FILM-TECH

SERVICE UPDATE

BULLETIN NO: 15

SUBJECT: NEW "R" SERIES SCHEMATICS

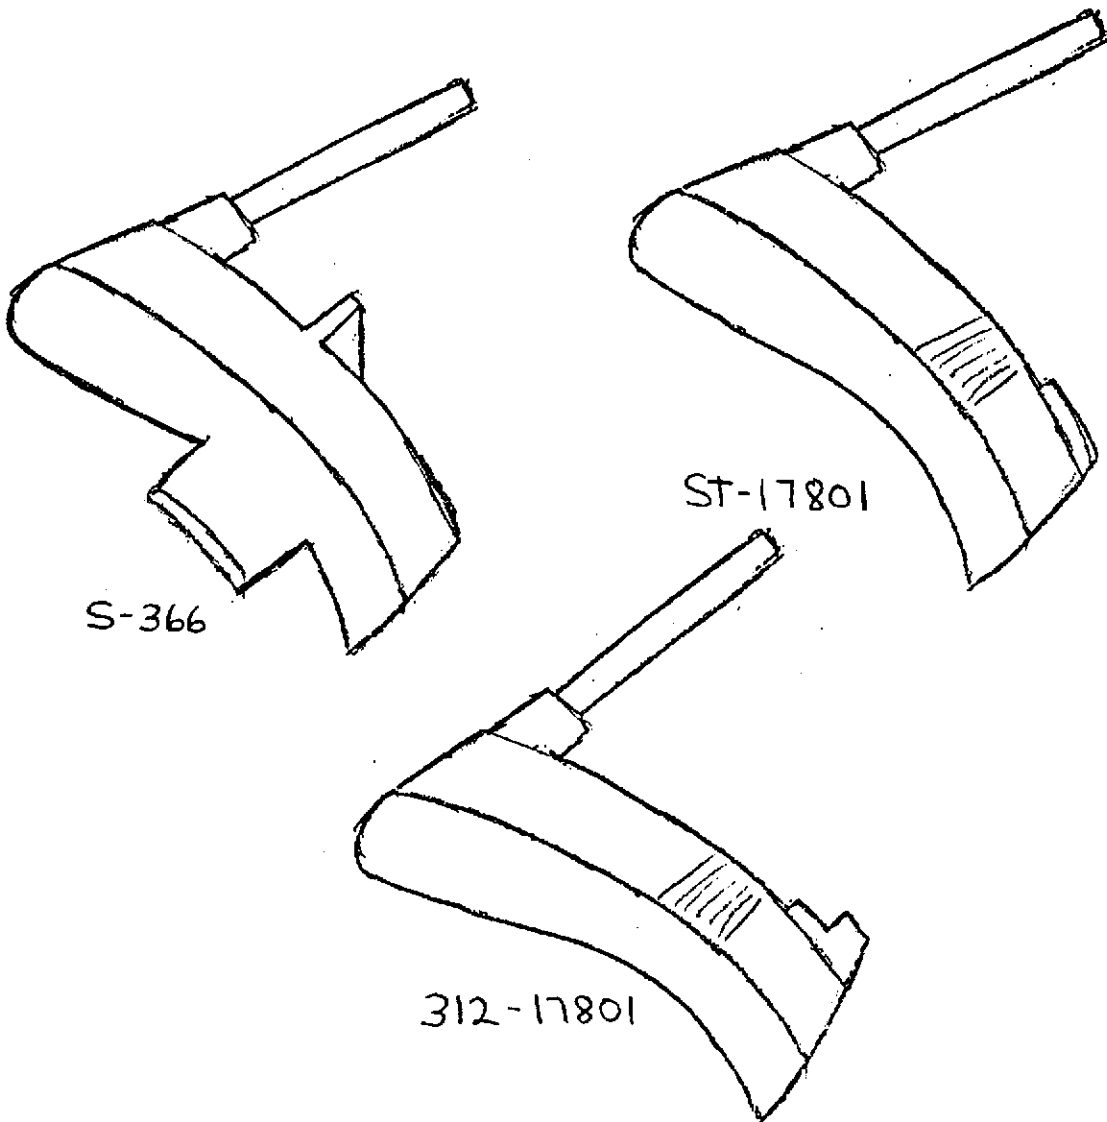
There are currently three types of No. 2 film guides used; P/N S-366, ST-17801 and 312-17801. The guides are not directly interchangeable.

The photo in the ST/M parts manual shows P/N S-366 as ST-17801. This is an error. Please use the illustrations below to determine the correct part number.

312-10101

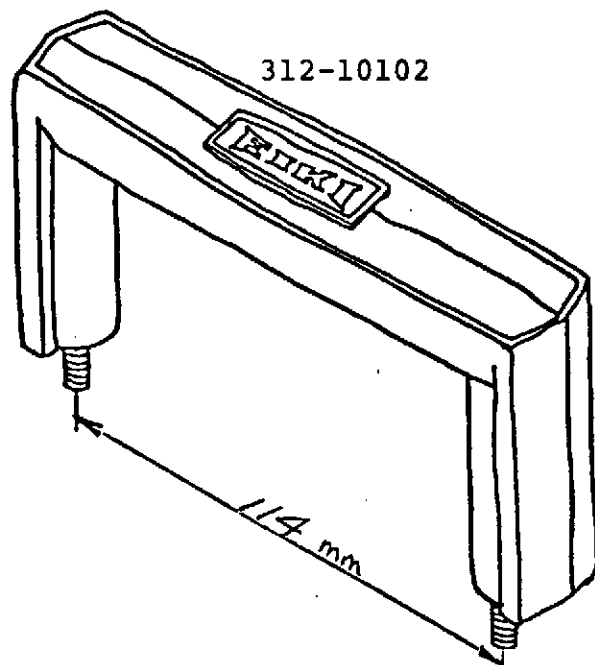
When the existing stock is exhausted, the 312-10101 swing-down handle will be replaced by the newer and sturdier 312-10102. To use the new handle on earlier models it is necessary to elongate the mounting holes as shown. Care should be taken to prevent metal filings from falling into the projector's mechanism.

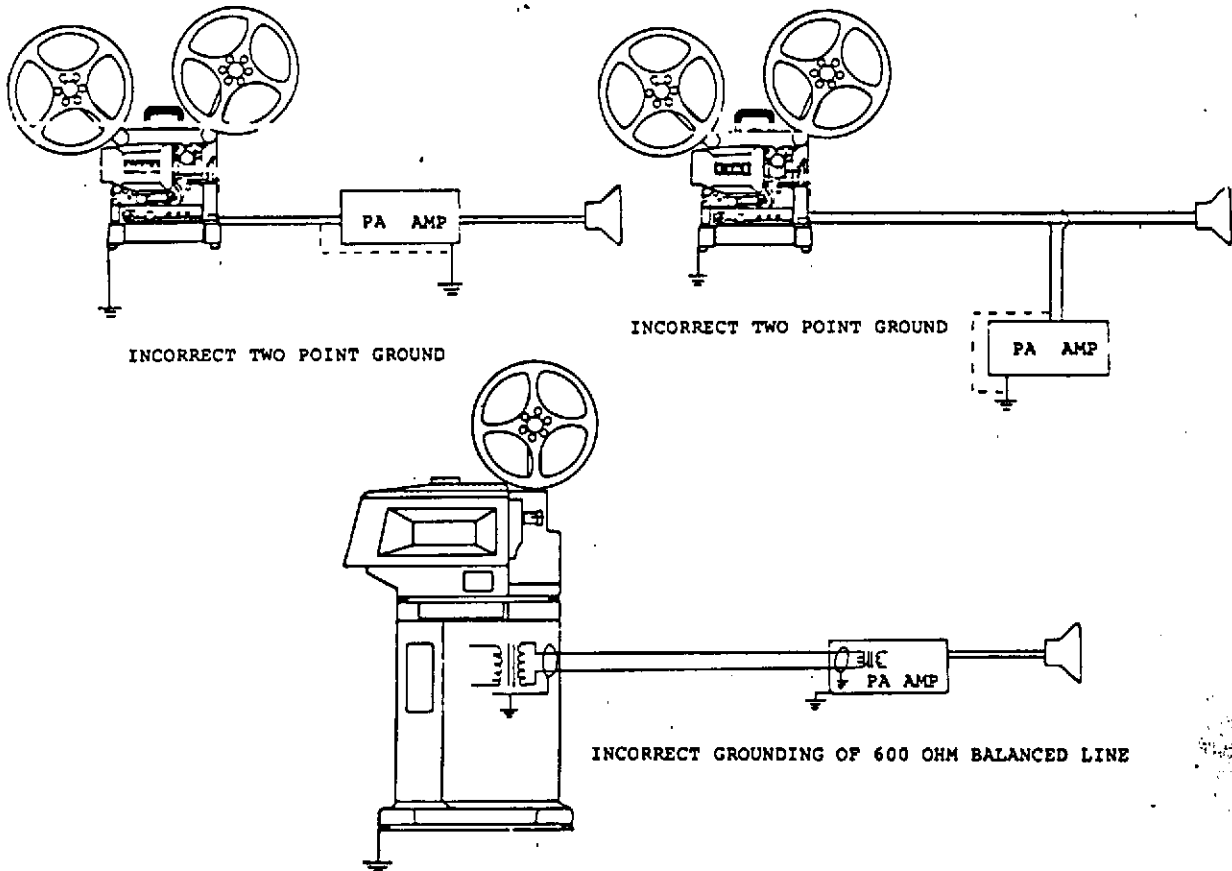
SUBJECT: Shutter Pulley Bushing Binding On The Cam Tank Shaft.
R Series and EX-2000 Projectors.

It has become apparent that under some extreme circumstances, where the still clutch is being used frequently and/or for extended periods, the shutter pulley can possibly bind on the cam tank shaft.

Recommendation:

1. For normal usage, clean the pulley bushing and shaft completely and apply a thin coat (P/N5631) petroleum oil.
2. When re-installing the pulley, apply a very thin film of (P/N5630) silicone oil to the clutch surface. (see above).
3. In extreme cases of high usage such as in the Marc 300/350 conversions, EX-2000 and some driver training systems, the 312-11801 shutter pulley should be replaced with the 260-11801 pulley which uses an oil-lite bushing.
4. To lubricate the 260-11801 pulley, use a thin film (P/N5631) petroleum oil. (Do not use silicone or Molybdenum Disulfide grease. The silicone oil does not mix with the oil-lite bushing oil, and the Moly grease tends to close the lubricating pores in the bushing).

CURRENTNEW

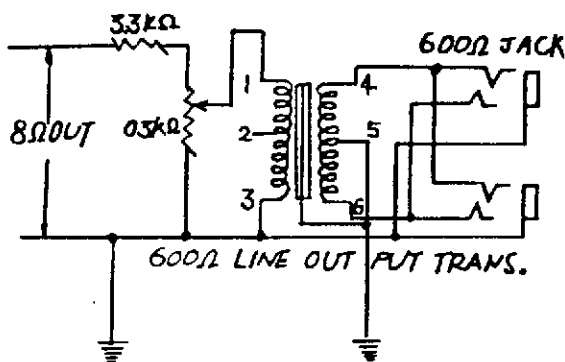
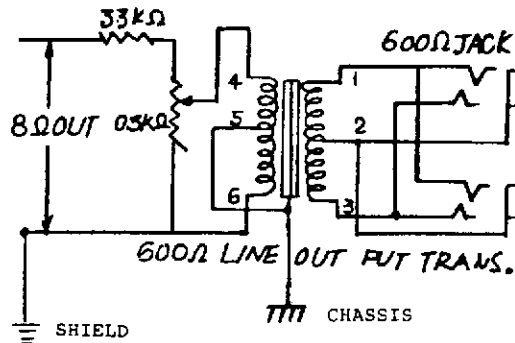
Beginning with the following serial numbers, the 600 ohm balanced output wiring has been changed to reduce the possibility of ground loops. (Two point grounding).

We recommend that when servicing current amplifiers, that they be modified by reversing the primary and secondary terminals and connecting the center tap terminal #2 to the ¼ inch phono jack ground sleeve, as shown below.

ROTARY SWITCH ASSY

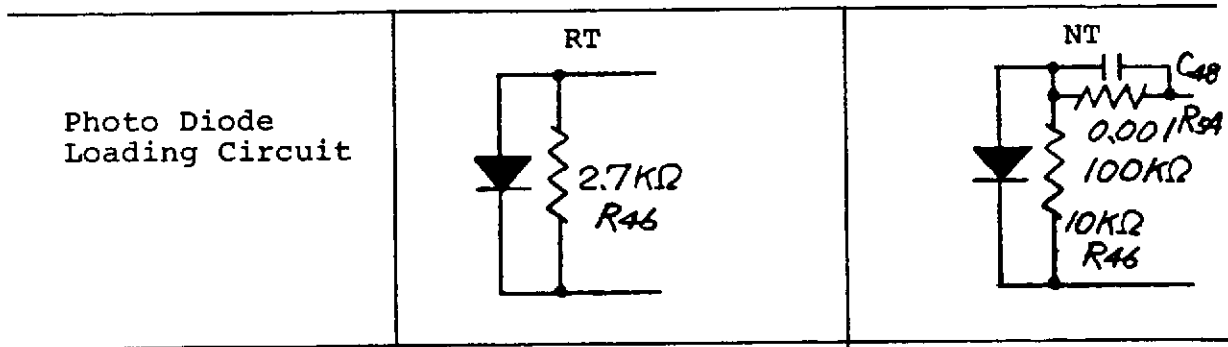
Currently there are two different types of Rotary Function Switches used on the EX-6000 projectors:

Switch P/N 260-60501 S/N 6001 to 6143

Switch P/N 260-60502 S/N 6144 and up

These switches are not interchangeable even though they physically appear similar. The difference between the two switches is the switching sequence as determined by the cam set-screws. The position of these screws is factory adjusted and sealed. They should not be tampered with. In the event the screws have been adjusted, it is recommended that the complete assembly be replaced.

To identify the two switches, set the function control knob to the reverse position:

Switch 260-60501 #5 micro switch is activated

Switch 260-60502 #5 micro switch is not activated

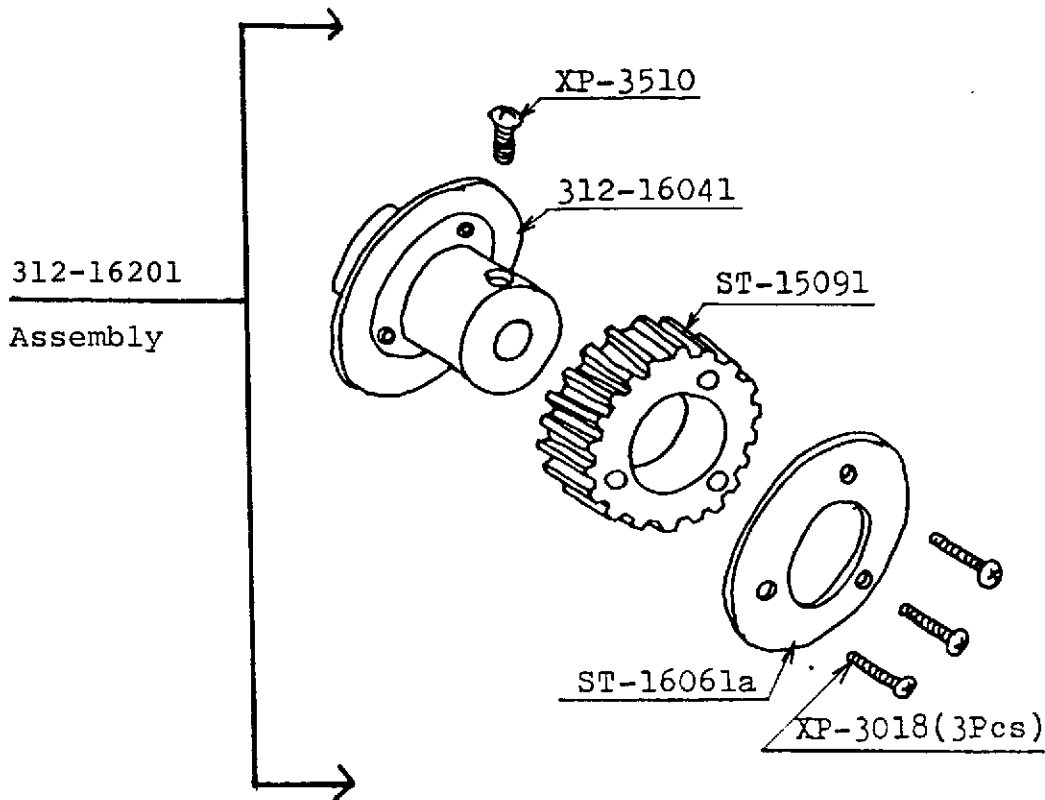
The 312-16201 drive gear assembly has been changed to a new injection molded drive gear 320-16201 which is directly interchangeable.

The individual parts as shown above are no longer available as separate items. In the future, please order the 320-16201 replacement assembly.

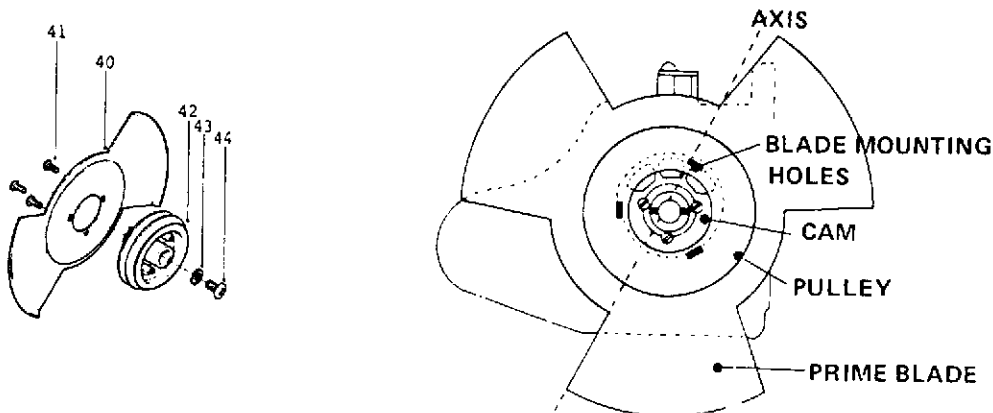
There is a possibility that the shutter pulley screw (44) XT-4010S may loosen up and damage the shutter blade, or that the three XT-2308 screws (41) may work loose, particularly when the shutter blade has been replaced. It is recommended that when changing shutter blades or servicing the cam tank that the screw XT-4010S (44) be replaced with an XT-4012S and add a lock washer WC-40 between the flat washer ST-20041 (43) and the screw (44).

The shutter blade mounting screws XT-2308 (41) should be replaced with self tapping screws 320-11331. (To assure correct shutter alignment, replace screws (41) one at a time only). For correct orientation of the shutter and pulley assembly, refer to the above illustration or page 26 of the Service Manual. (Two bladed shutters require no special orientation, only three bladed). Damaged or broken shutter blades and pulleys will be handled as a normal warranty item through authorized EIKI dealers. The screws and washers will be supplied as a kit at no charge. Please order quantities only as needed.

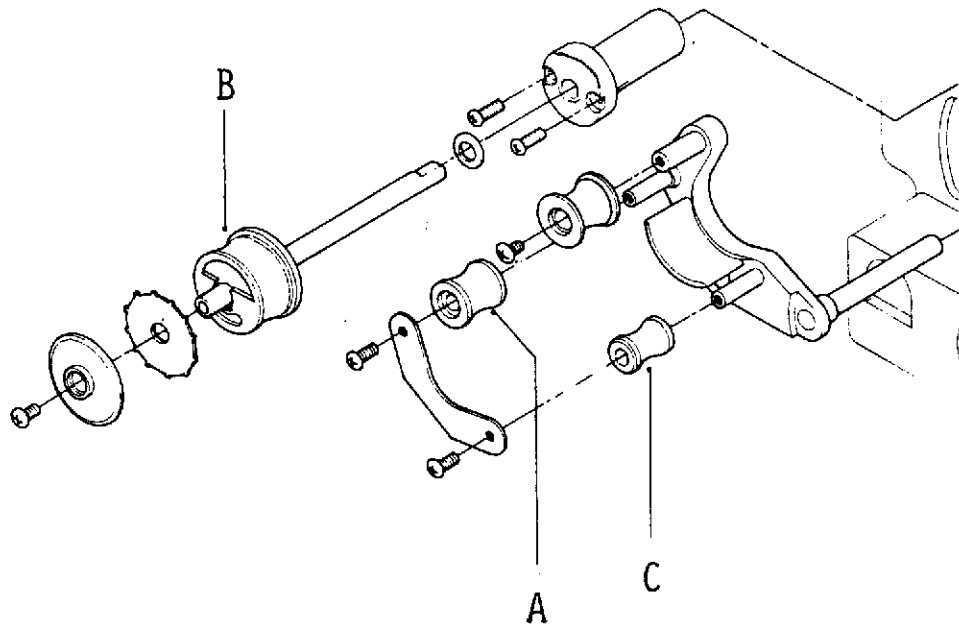
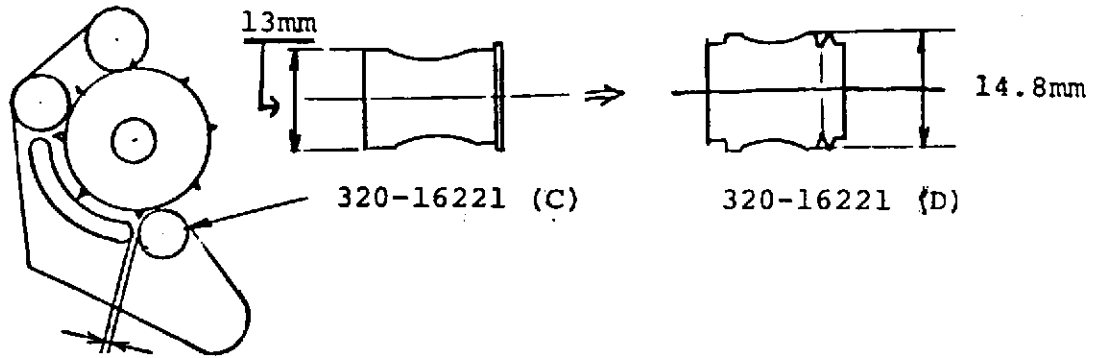
Under certain conditions such as old black and white films with extreme shrinkage or excessive and erratic take-up tension, the film will skip the #2 sprocket. When this occurs, the lower loop will shorten causing the auto-loop setter to reset. The upper loop is reduced until it trips the "Film Guard" sensing roller, turning "Off" the projector.

To insure positive film seating around the #2 sprocket drum, the following modifications should be made.

- A. SL-II Projectors prior to S/N 45,000 and EX-300SL-II models prior to S/N 3287, the 320-17561 Shoe Roller should be replaced with 320-17561 (A) Shoe Roller as per service update #113.
- B. SL-II Projectors from S/N 30,000 to S/N 52305. The #2 Sprocket Drum Assy., 314-1640 (28.74mm Dia) should be replaced with 321-16401, #2 Sprocket Drum Assy. (28.60mm Dia). EX-300SL-II, S/N 1898 to S/N 3658. The #2 Sprocket Drum Assy. should be replaced with the 210-16401 (A) Aluminum Sprocket Drum Assy.
- C. SL-II Projectors from S/N 30,000 to S/N 52305 and the EX-300SL-II, below S/N 3658. The small Sprocket Shoe Guide Roller, 320-16221 should be replaced with the new 320-16221 (D) Guide Roller.

NOTE: The increase in the 320-16221 (D) Roller diameter may require a slight trimming of the Film Shoe.

Trim to allow small clearance.

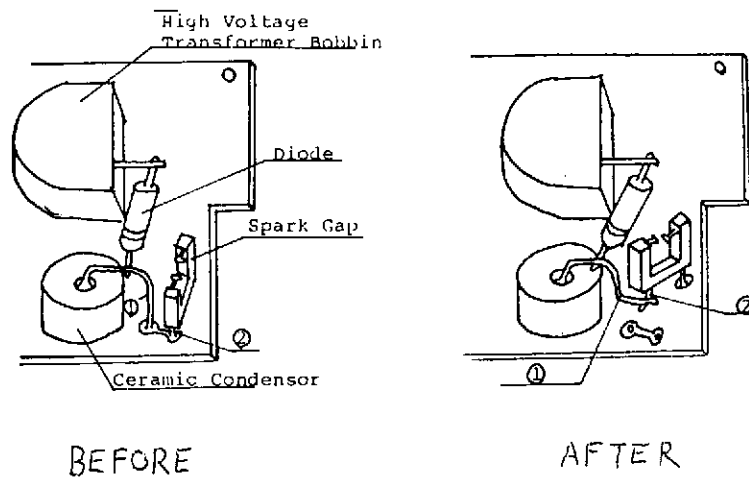
SUBJECT: Difficult lamp striking due to high voltage leakage.

Projectors in the serial number group as indicated may be more susceptible to high voltage leakage from the starter P.C. board to ground. The result is a lower ignition voltage which may not always start the xenon lamp. To correct the above condition, unsolder the spark gap and ceramic condenser from the P.C. board and solder the two terminals directly together. (See the illustration below.)

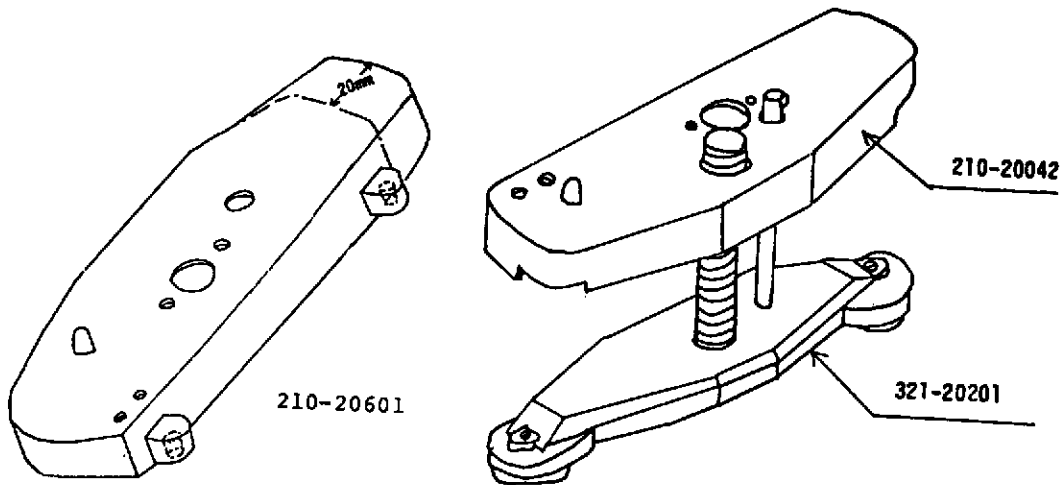
SUBJECT: FRONT AND REAR LEG ASSEMBLY

MODEL: EX300SL AFTER S/N 3458

As a continual product improvement the front and rear leg assembly have been widened for greater projector stability.

REMOVE C-7

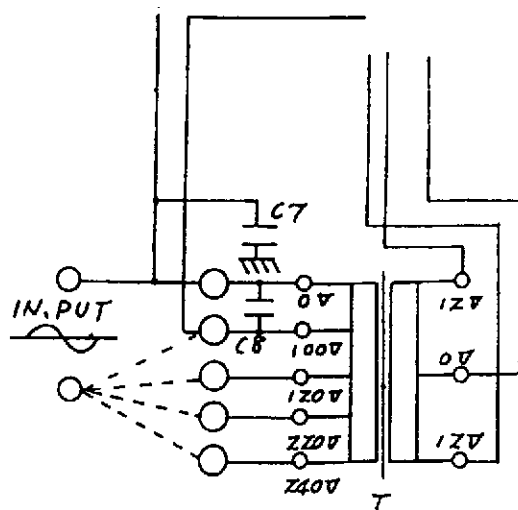
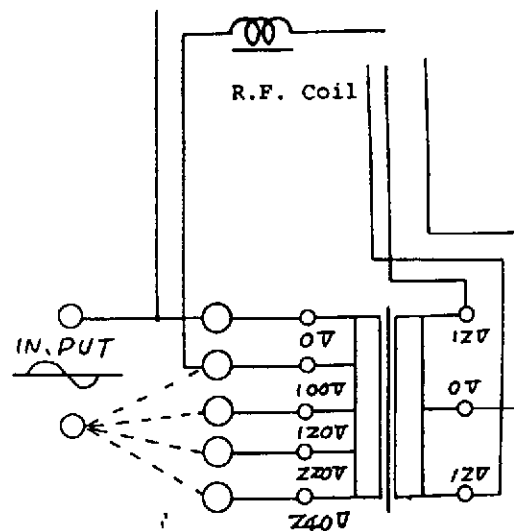
TO REDUCE THE LEAKAGE CURRENT, REMOVE THE BOTTOM PLATE, LOCATE R.F. BY-PASS CAPACITOR (C-7, 0.1 MFD-400V) AND REMOVE. INSTALL R.F. CHOKE COIL (980-13471) IN SERIES WITH THE 100V TAP AS SHOWN BELOW.

INSTALL R.F. COIL
